Borough of Broxbourne

Original consultation response

Report to the Planning and Regulatory Committee dated 18th April, 2017

To advise the Committee of the main issues related to the proposed Veolia Energy Recovery Facility at Ratty's Lane, Hoddesdon and to seek members' preliminary views on the development.

Elevation C - North Western Facade
1:250

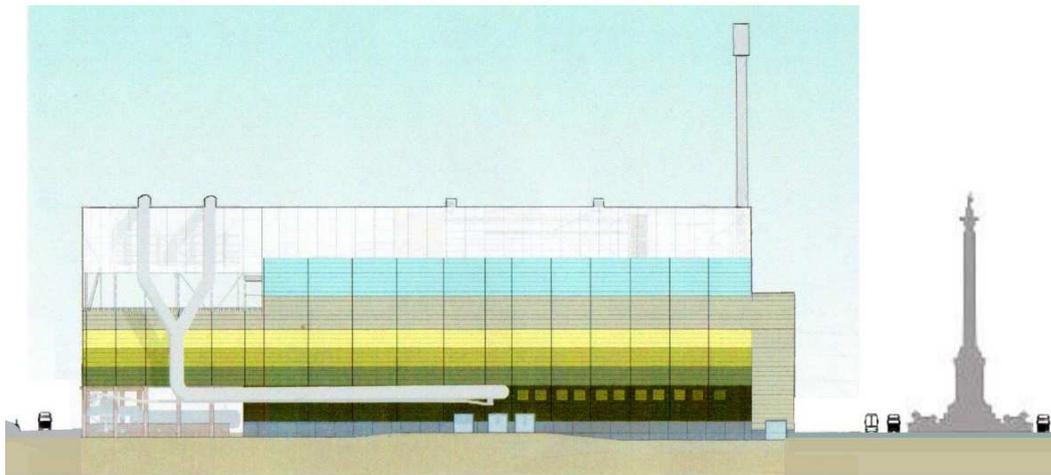
1 The sheer size of the development is immense: chimneys are 86.75m (over 284ft) high. This is visually intrusive on a grand scale. This will be the tallest building in Hoddesdon. It is claimed that the proposed stack height will allow for dissipation of particulates, but the latter will still settle but on a wider scale. However much is made in mitigation in terms of short distance or long distance views of the scheme, the view will still be intrusive. It is noted that luminaires are to be located at higher levels: this will also be intrusive because the added lighting will be seen over a wider area. It is unreasonable to claim mitigation in respect of spoilt views when trees are in full leaf resulting in "increased density" in foliage - what about the other 6 months?

**VIEWED FROM THE NORTH WEST (i.e. across the railway line)
AND
COMPARED (at the same scale) WITH NELSON'S COLUMN**
